To: Kristopher Byrd, Well Construction and Compliance Section Manager
From: Travis Kelly, Well Construction Program Coordinator
Subject: Review of Water Right Application G-18994
Date: September 22, 2020

Application # G- 18994

TO: Water Rights Section Date 09/17/2020
 FROM: Groundwater Section M. Thoma
Reviewer's Name
 SUBJECT: Application G- 18994 Supersedes review of _____
Date of Review(s)

D1. Well #: 1 Logid: KLAM0001501

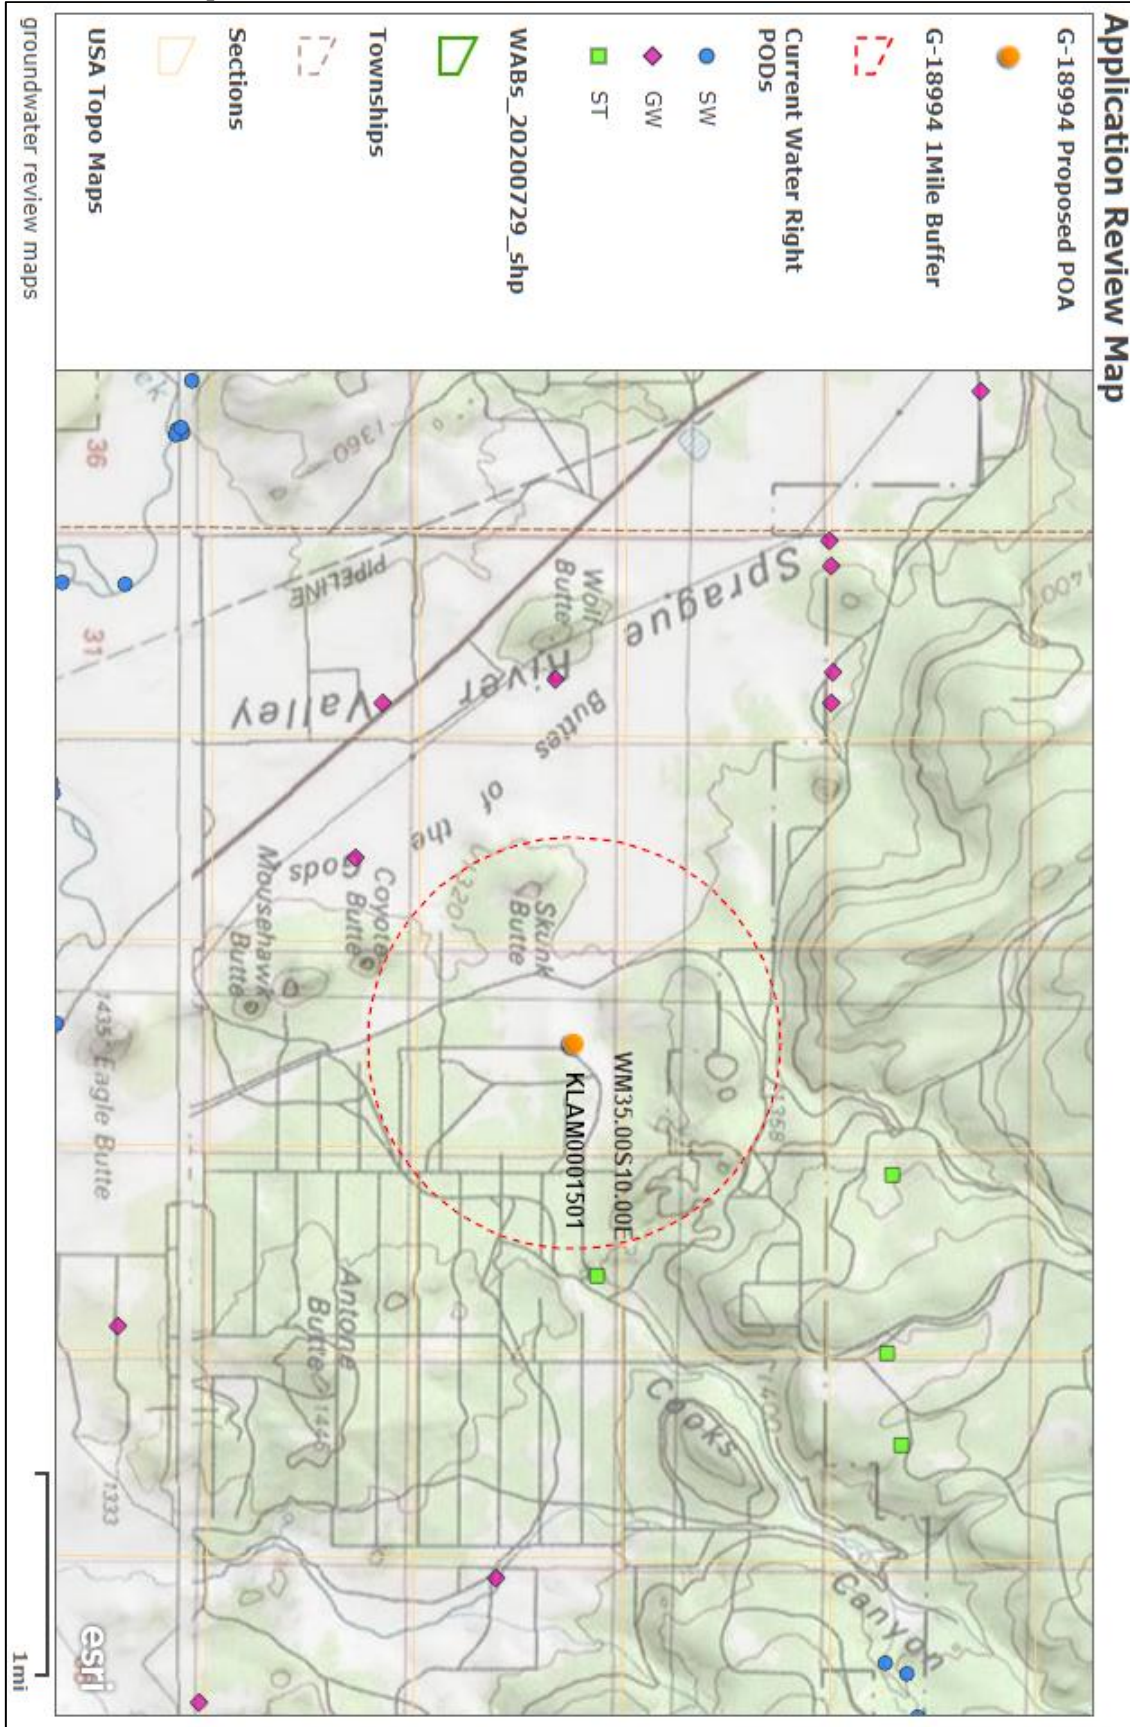
D2. **THE WELL does not appear to meet current well construction standards based upon:**

Seal depth appears to be insufficient to eliminate commingling between aquifers.

D4. **Route to the Well Construction and Compliance Section for a review of existing well construction.**
